NUCLEAR ENERGY INSTITUTE

July 11, 2003

**REFERENCE:** Solicitation of Public Comments on Draft NMSS Policy and Procedures Letter 1-82 and Backfit Guidance (Fed. Reg. Vol. 68, p. 35015, dated June 11, 2003)

Figure 1. NMSS Backfit Process Flow-chart

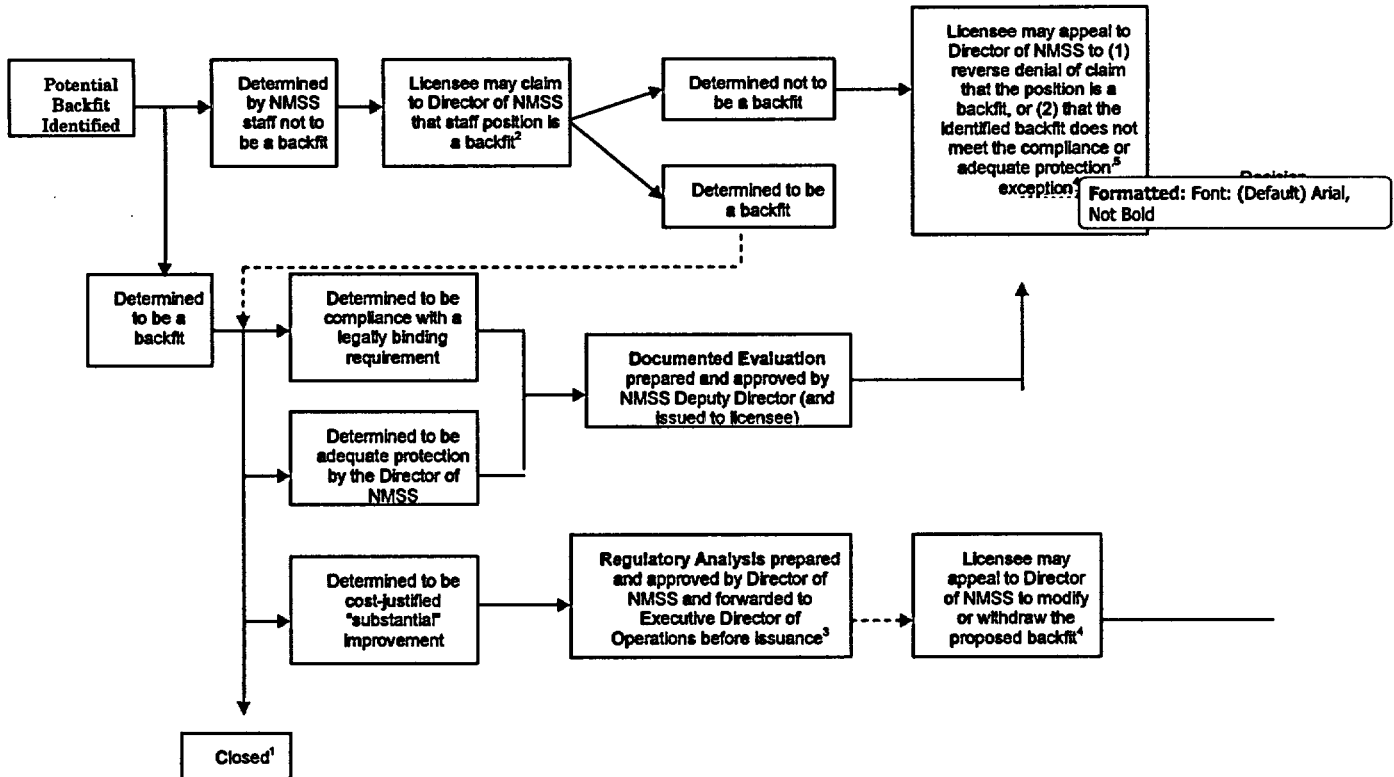
- references to Part 76 backfitting should be included in addition to those for Part 50 licensees. (e.g. references 28 & 29 in Paragraph X)
- a single, unified flowchart of the backfit process is preferable to the three figures included in PPL 1-82

[Comment: use of three flowsheets seems somewhat unnecessary. Recommend use of a single flowchart as noted on the next page.]
